# Access Compliance Report

## Public Rights-of-Way

Intersection ID: 23697	Main Street: ABBOTSWOOD_DR	Cross Street: COLONY_RD	Location: NE
ADA ID: 016537492691	Ramp Type: ParaDiag	Initial Pass/Fail: Fail	Overall Compliance: No
		Severity Score: 25

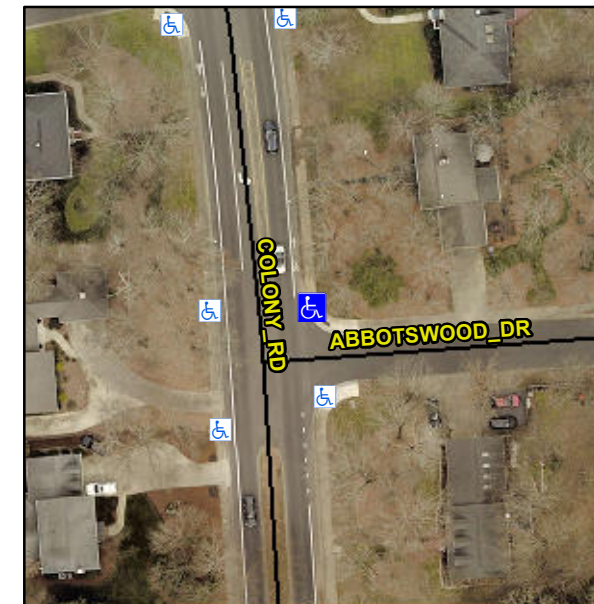
Surveyor Notes:

**LT RP < 5%**

PROW/ADA:

**R304.3.2**

Possible Solutions:

**Remove & Replace Curb Ramp With Two New Directional Ramps or Equivalent.**
